## ASSESSMENT REPORT

### Springvale Water Treatment Project

#### Brine Management and Pipeline Realignment Modification (SSD 7592 MOD 1)

**Figure 2: Proposed new brine management process**

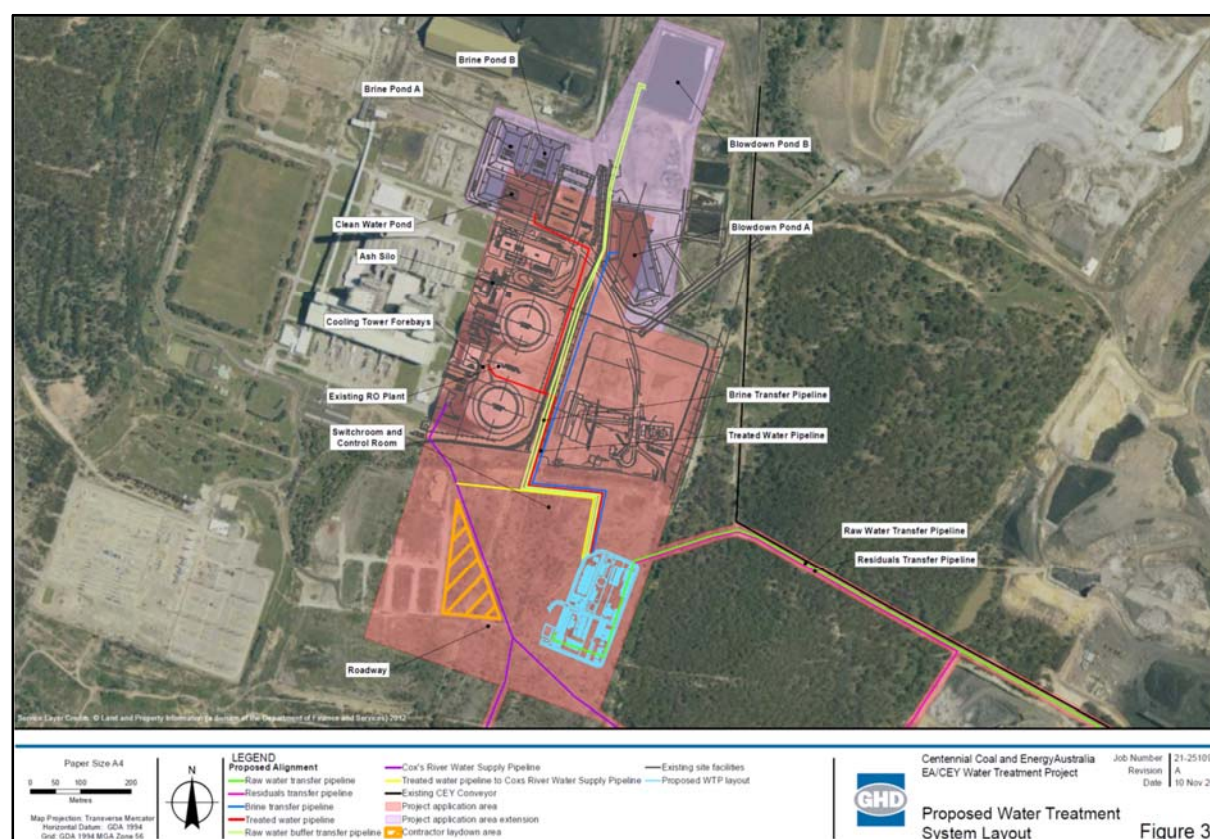
Firstly, it proposes to change the management process for the brine stream from the reverse-osmosis plant. The approved process involves sending the brine through a concentrator and a crystalliser which would turn the brine into a slurry, and then temporarily storing the slurry in holding ponds before emplacement. The proposed new process would instead send the brine directly to an upgraded crystalliser, which would dehydrate the brine and allow it to be stored in existing ponds (see **Figure 2**).

**WaterNSW** asked if the proposal would change the approved way that brine would be stored at the existing power station ash dams, and for clarification about whether the proposed new brine management process would affect local water quality. These matters are addressed in **section 5.1**.

The proposed brine management process would change the chemical composition of the brine and result in a dehydrated (i.e. non-liquid) brine product. This brine product would therefore no longer be held on site in dedicated evaporative holding ponds before being emplaced. It would instead be stored in existing (repurposed) ponds to the north of the power station's cooling towers (see **Figure 2**).

The proposed brine management process would also increase the compaction level of the emplaced brine product as compared to the brine slurry resulting from the currently approved process. This would reduce the risk of potential leaching to the groundwater table and remove the need to add sulfuric acid to the brine to balance pH levels prior to emplacement.

The brine product would still be emplaced within the approved brine ash emplacement areas. Due to the elimination of additional holding ponds and the changed chemical composition of the brine product, the proposed brine management process would reduce any risks to local water quality.

The Department is satisfied that the proposed new brine management system aligns with the aims of the Brine and Residual Waste Disposal Plan in terms of reducing soil contamination risks and considers that no additional conditions are required.

**Figure 3: Proposed water transfer pipeline infrastructure changes**

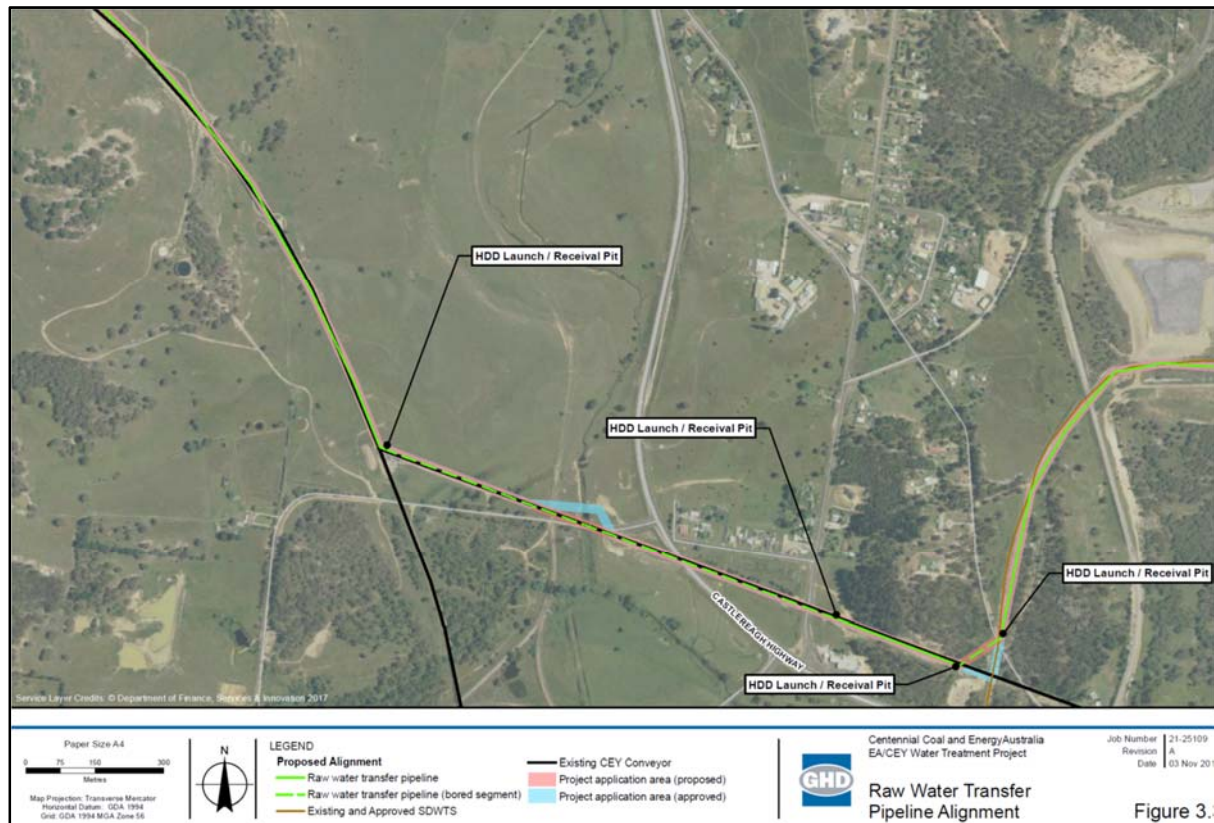
- minor realignments of the water transfer pipeline near Lidsdale in the vicinity of Skelly Road, the Castlereagh Highway and the Coxs River, to allow more effective directional drilling (see **Figure 3**);
- installing a hydraulic break tank on the water transfer pipeline at the top of the Newnes Plateau escarpment to minimise pumping requirements; and
- installing hydraulic controls on the residuals transfer pipeline and a minor alignment change to a small section to avoid a reject emplacement area at the Western Coal Services site.

The minor realignments of the transfer pipeline would avoid the kinks in the approved pipeline alignment where it underbore the Coss River and the Castlereagh Highway. It would also eliminate a 90-degree turn in the pipeline near Springvale Coal's overland coal conveyor (see **Figure 3**).

These minor alignment changes would result in a more efficient construction of the pipeline and increase its operational efficiency. The changes to the alignment beneath the Castlereagh Highway would still be subject to the requirements of RMS, which did not object to the proposal.
